D1 Community Centre
 APPROVED PLAN 20 / 1469 / FUL
 North East (Front) Elevation

D1 Community Centre
 PROPOSED MATERIAL CHANGE
 North East (Front) Elevation

**MATERIAL SCHEDULE (D1 - COMMUNITY CENTRE)
 PROPOSED NEW ALTERNATIVE MATERIALS**

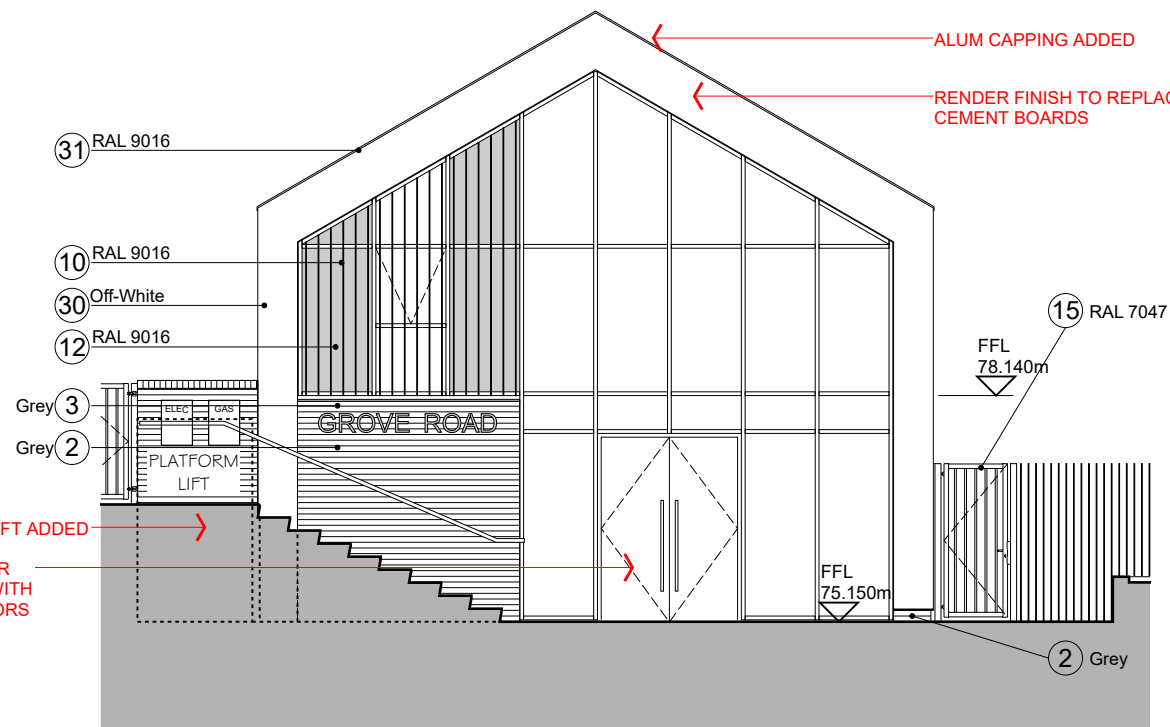
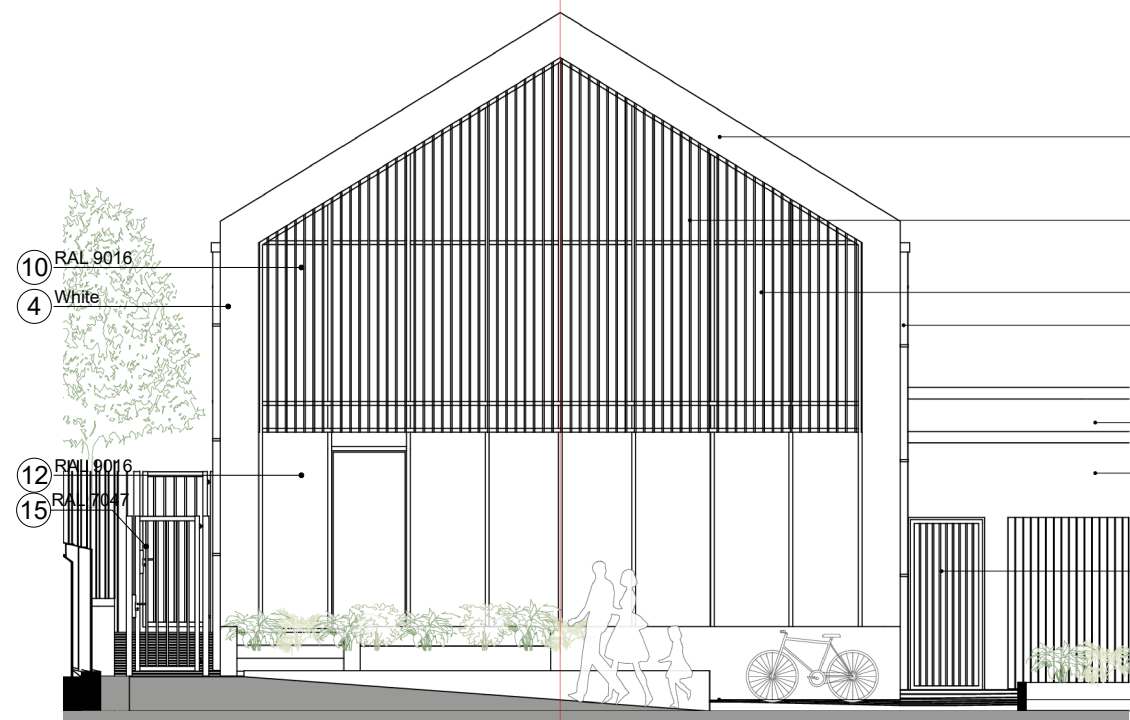
- 30. Off white render finish
- 31. Aluminium PPC full width coping (RAL 9106)
- 05. Eternit Birkdale 600x300mm blue/black fibre cement slate effect (to match residential main roof)
